Agenda item: 650-591

Title: Figure F-2, 16t, Maximum Width

Date: Nov. 14, 2005 Revision: 1
 May 17, 2004 Revision: 0

Proposal: Modify Figure F-2 per attached figure, dated 11/14/05.

Proposed Figure F-2

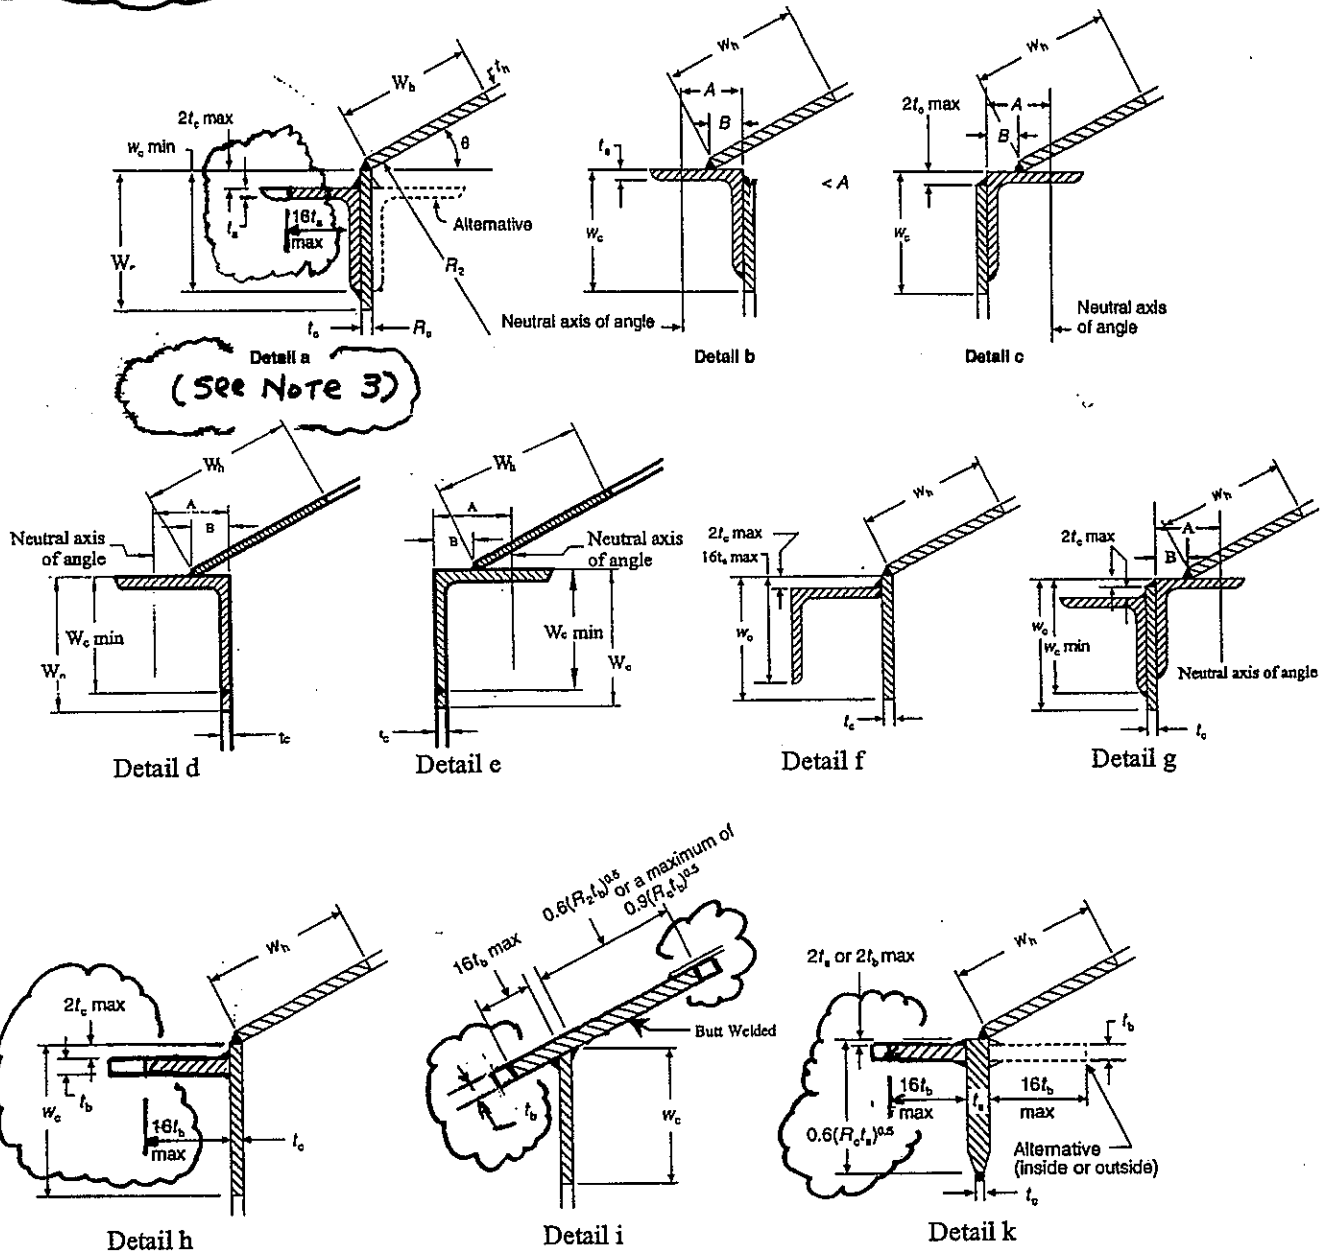
Purpose: More clearly depict, in API 650 Figure F-2, the limit of "16tb max" for horizontal members that are wider than 16 tb.

Rationale: The original inquiry dealt with Addendum 2, Figure F-2, detail g only. This issue is common to other bar details. Agenda item scope was extended to rim angles. Details a-j, excluding detail f, have been altered to make it clear that members can be wider, but no credit is allowed in the compression area calculation.

add:

3. The limit on the horizontal dimension, $16 t_a$, for rim angles applies to details a thru e and g.
